Office Action Summary

10/733,515

LEE, CHOONG-JAE

DETAILED ACTION

FIG. 6

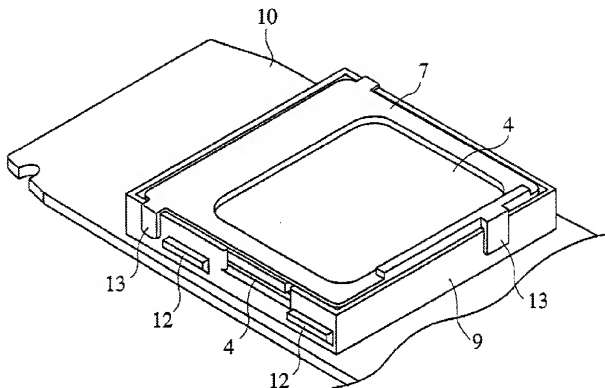
With respect to the Applicant's arguments that "*a predetermined air gap is not formed between an upper surface of the supporting rib and a lower surface of the first cover,*" the Examiner disagrees. As shown in the Figure 6 below, the claws (13) of rubber sheet (7) provides a thickness above the rib (9) such that an air gap is formed therebetween the upper surface of the rib and the lower surface of the first cover. \

Therefore, the rejection is maintained.
